RENESAS TECHNICAL UPDATE

Product Category	MPU & MCU	Document No.	TN-16C-A197A/E	Rev.	1.00
Title	Errata to R32C/157 Group Hardware Manual		Information Category	Technical Notification	
Applicable Product	R32C/157 Group	Lot No.	Reference Document	R32C/157 Group Hardware Manual Rev. 1.03 (REJ09B0507-0103)

This document describes corrections to the R32C/157 Group Hardware Manual, Rev. 1.03.
The corrections are indicated in red in the list below.

Figure 24.33 LIN Low Detection Interrupt Block Diagram

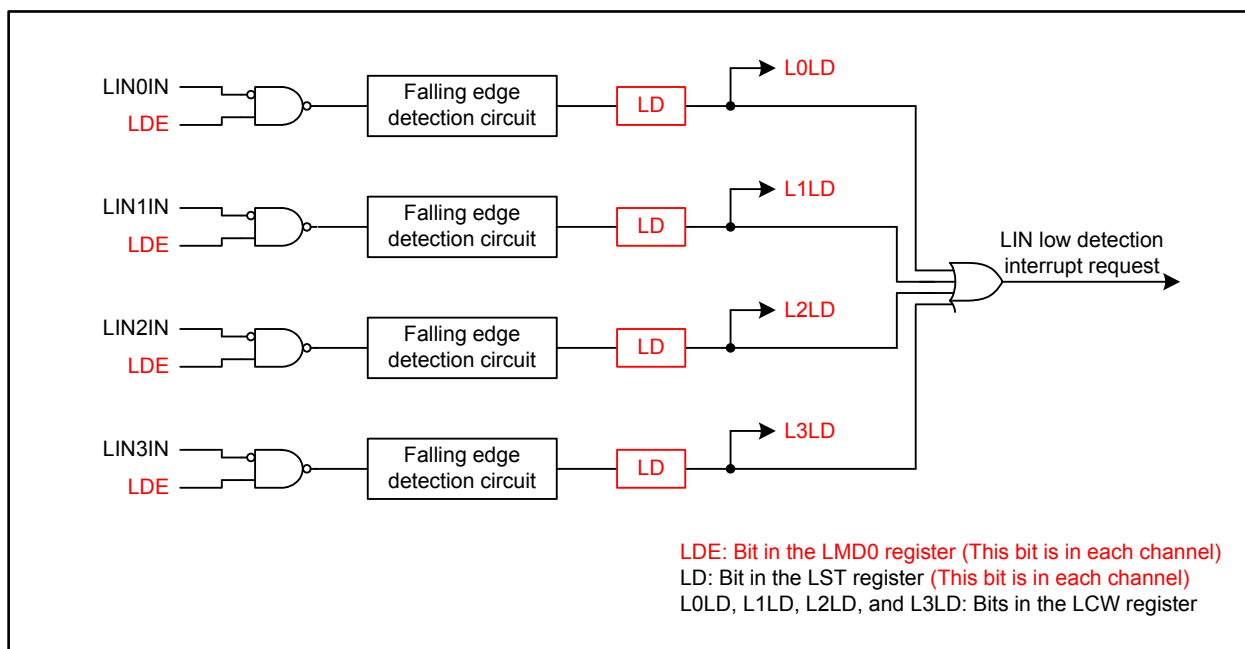
- Page 437 of 636, Figure 24.33 is corrected as follows:

Figure 26.1 Typical I/O Pin Block Diagram (i = 0 to 15; j = 0 to 7)

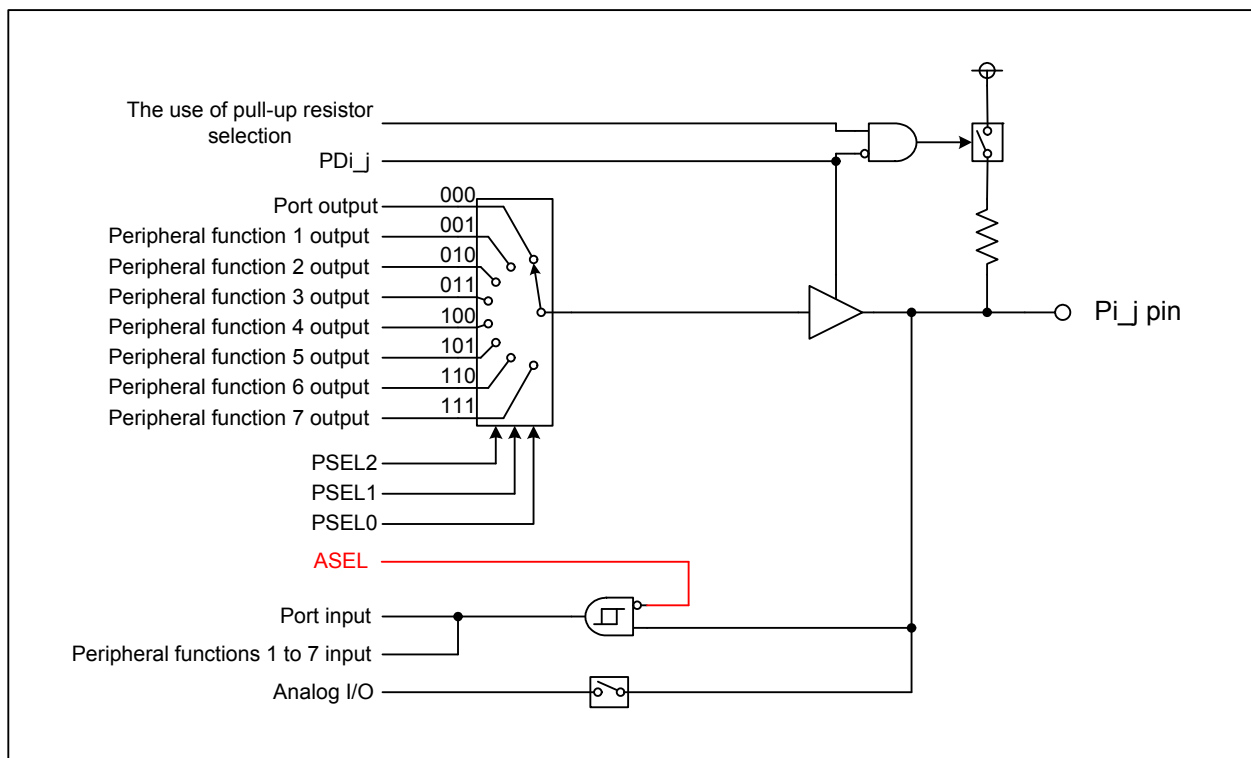
- Page 507 of 636, Figure 26.1 is corrected as follows:

Figure 27.2 Addresses for ID Code Stored

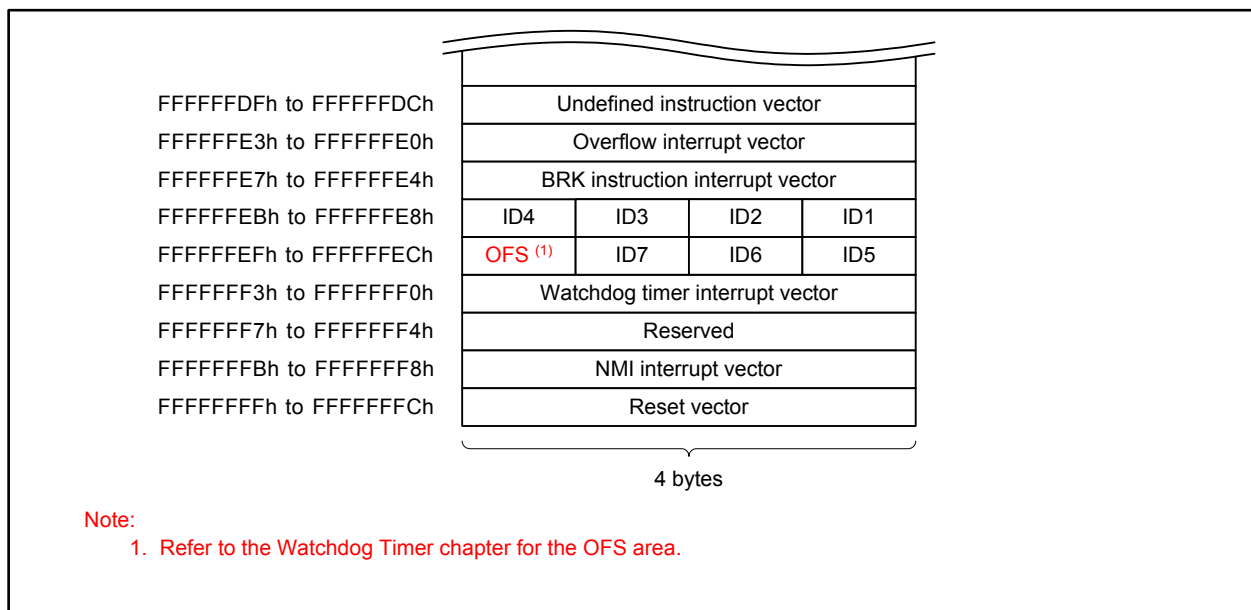
•Page 541 of 636, Figure 27.2 is corrected as follows:

Figure 27.12 Read Timing

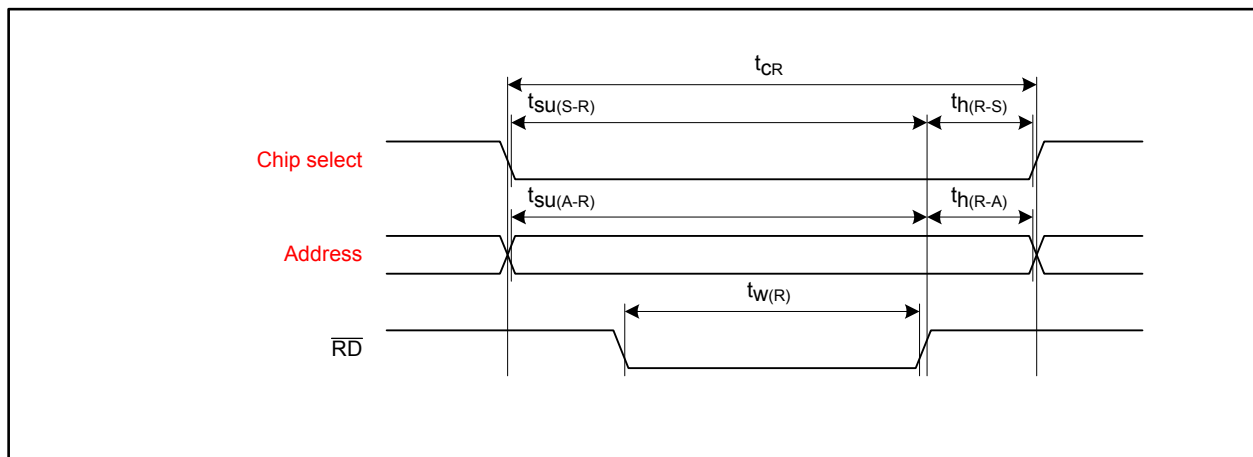
•Pages 549 and 551 of 636, descriptions in Figures 27.12 and 27.13 are corrected as follows:

Figure 29.5 Flash Memory CPU Rewrite Mode Timing

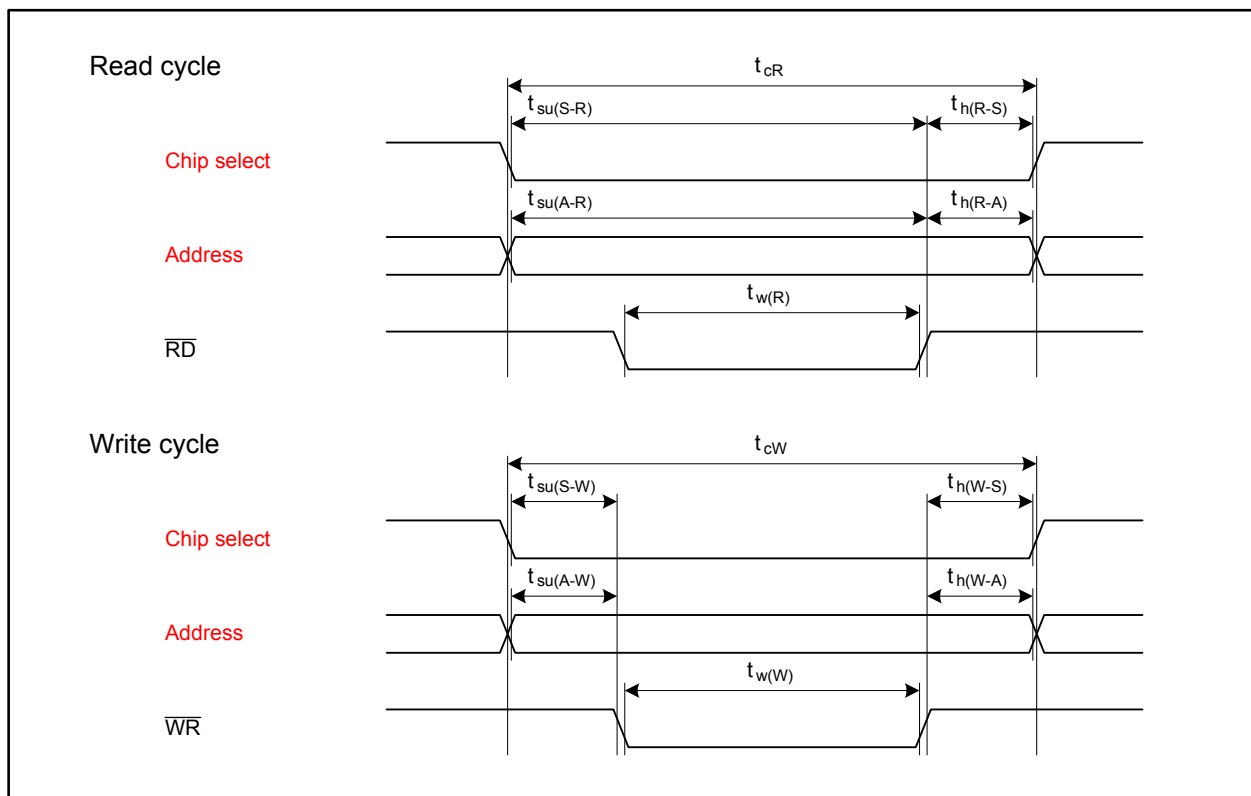
- Page 569 of 636, description of Note 3 in Figure 28.2 is corrected as follows:
 “When this bit is set to 1, the module stops ongoing operations to enter its initial state. However, the registers are not initialized.”
- Page 569 of 636, description “This mode setting prevents data from being overwritten if a program goes out of control.” is deleted from Note 5 of Figure 28.2.
- Page 571 of 636, figure title “F2FI Register” for Figure 28.7 is corrected as follows:
 “E2FI Register”
- Page 575 of 636, description for EERR bit setting in Figure 28.12 is corrected as follows:
 “EERR bit in the E2FS0 register is 0?”
- Page 588 of 636, descriptions in Figure 29.5 are corrected as follows:
